**OPTIONAL SERVICE BULLETIN NO. DA20-24-05 REV. 0**

Type: DA20-A1

Replacement of the aircraft battery.

Figure 1. Schematic of battery cables

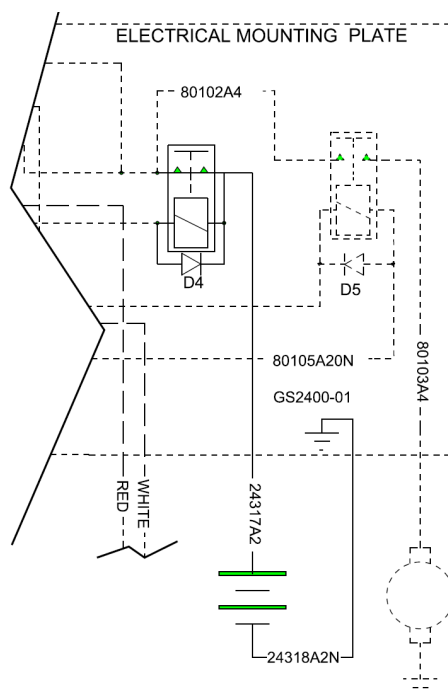
7. Install the new battery cables (items 3 and 4) to the electrical shelf. Refer to Figures 1 and 2.

**CAUTION: 2 AWG WIRING IS REQUIRED TO BE INSTALLED WITH THE POWER SONIC BATTERY. OTHERWISE, DAMAGE MAY OCCUR IN THE EVENT OF A SHORT CIRCUIT.**

Figure 2. Battery cables installation

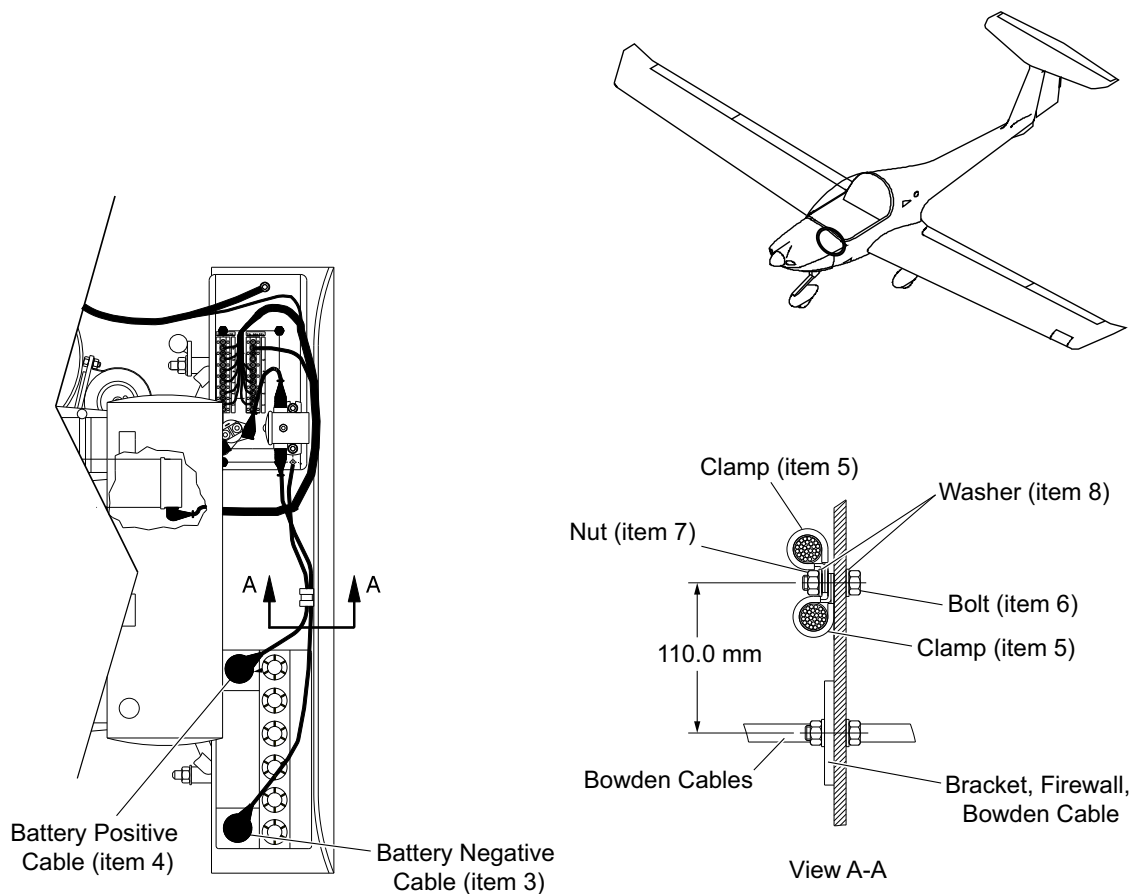
8. Install the bolt (item 6), washers (item 8), and nut (item 7) which attach the clamps (item 5) with the battery cables to the firewall.

Figure 3. Battery installation (looking inboard)

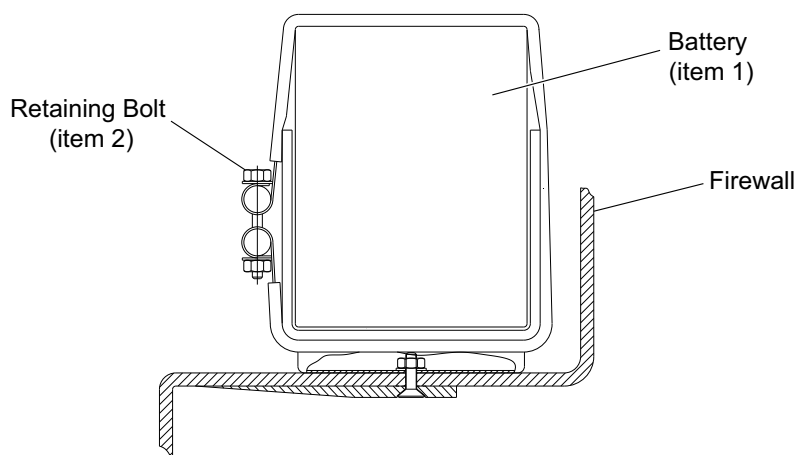
9. Install the new battery (item 1) using the existing strap with the new retaining bolt (item 2). Refer to Figure 3.
